SUBJECT: Class II Permissive change

FCC ID: MMAT75A

Saw filter change to LC filter

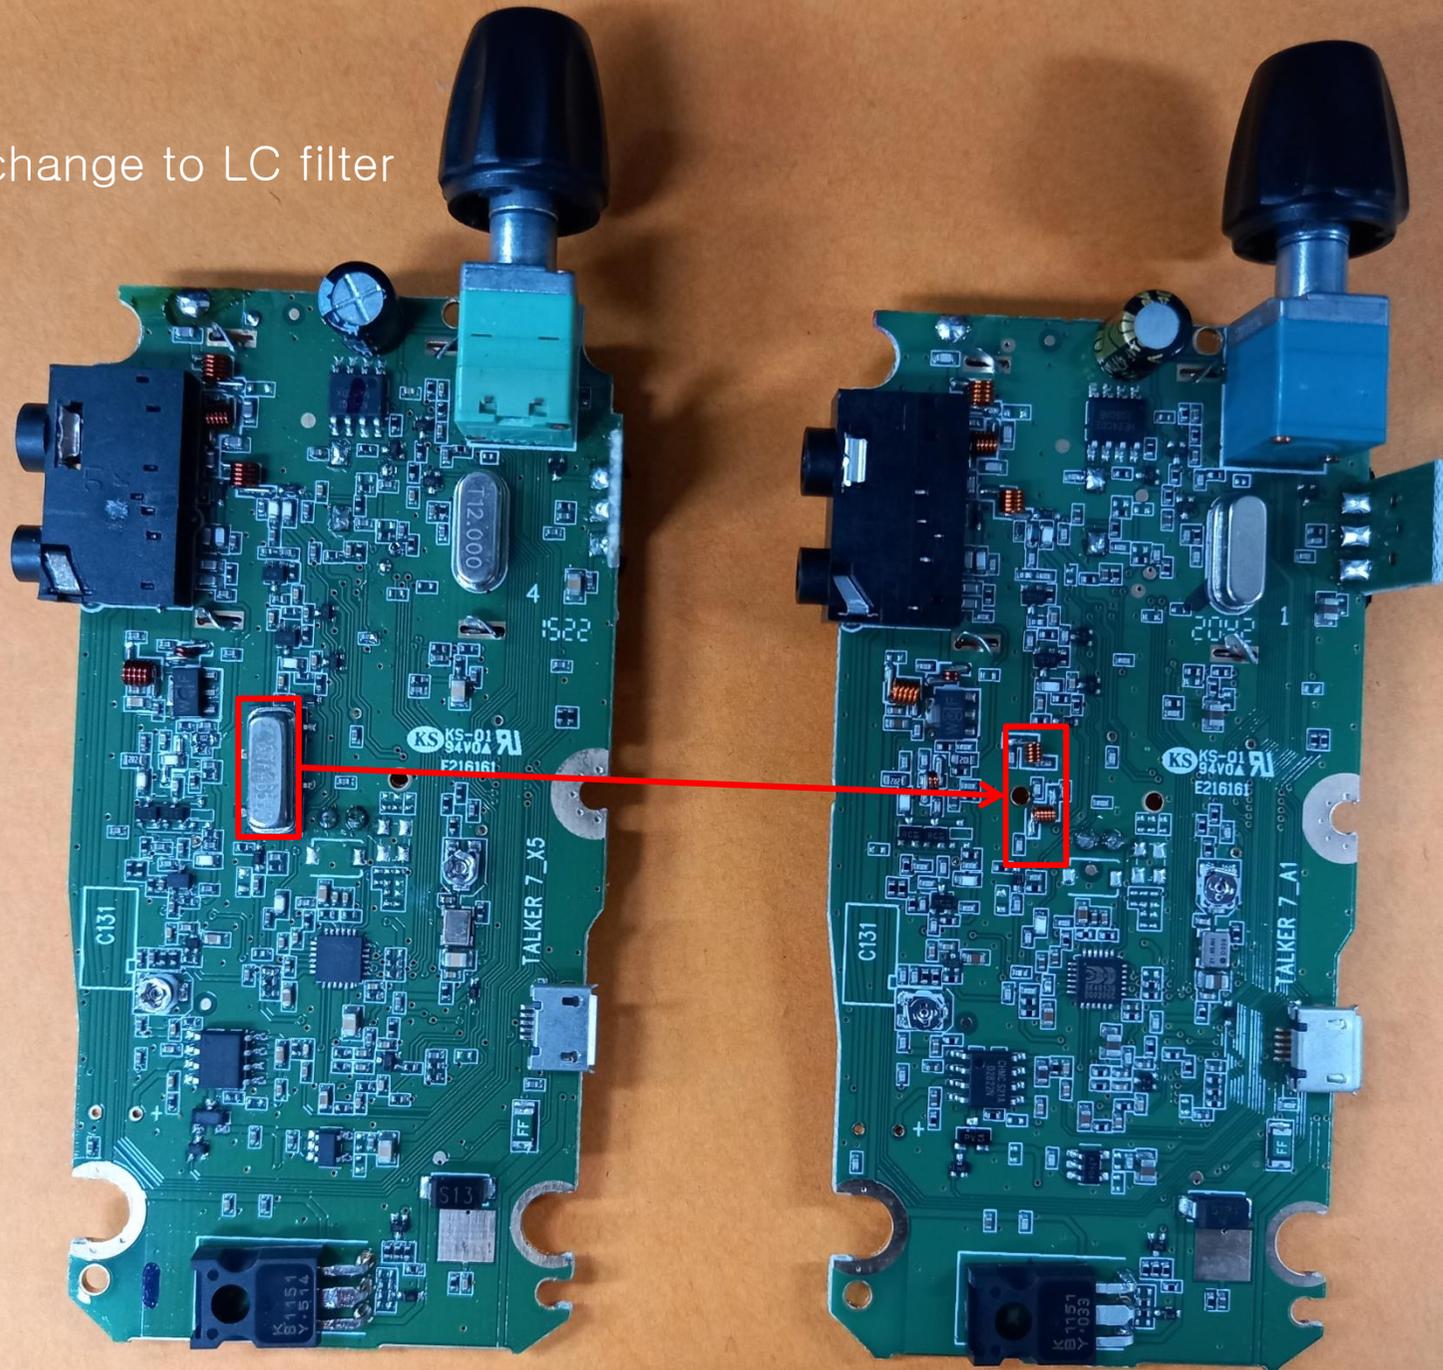
- 1) SF1(FTF465BS) of Saw filter change to Y18 LC filter(C71, C72, C75, C78, L16, L19)
- 2) IC6(GT809118) of Animal tone IC change to NY4B018C
